1 Products affected

Product hierarchy no. *	Part no.	SBU	Type / Description	Customer part no.
01 002 051 0000000558	0031.7601	Circuit Protection	FMS (250V)	-

2 Type of change

FMS (250V)					0118.2251	
creation date	created by	release date	released by	notification no.	revision	page
2014-11-27	dislercy	2015-01-29	dislercy		a	1 of 2

Old product appearance	New product appearance

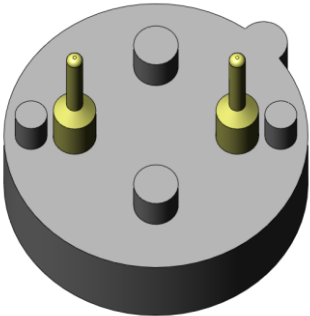
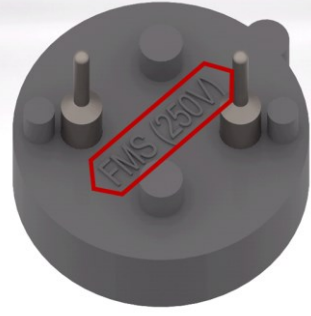
The fuse holder FMS (250V) gets an IEC approval from VDE. Thus, a type inscription on the socket is necessary.

Add a type inscription on the socket as follows:

Old label	New label

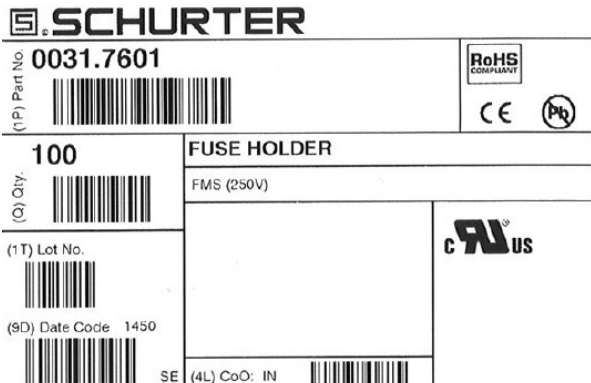
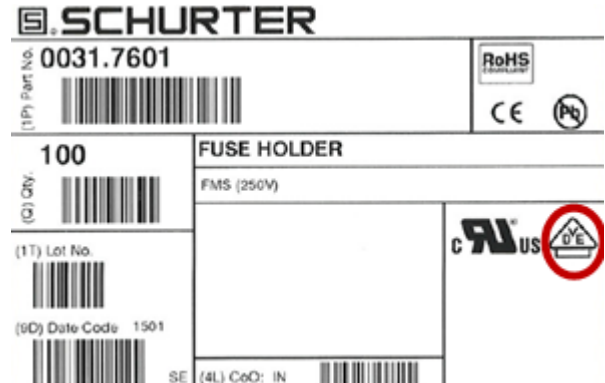
No rating acc. to IEC available	New rating acc. to IEC

<table><tr> <td>Rated power acceptance</td> <td>1.6 W / 6.3 A @Ta 23°C</td> </tr><tr> <td>Rated voltage</td> <td>250 VAC</td> </tr><tr> <td>Rated current</td> <td>6.3 A</td> </tr><tr> <td>Shocksafe category</td> <td>PC1</td> </tr><tr> <td>Overvoltage category</td> <td>II acc. to IEC 60664-1</td> </tr><tr> <td>Pollution degree</td> <td>3 acc. to IEC 60664-1</td> </tr></table>
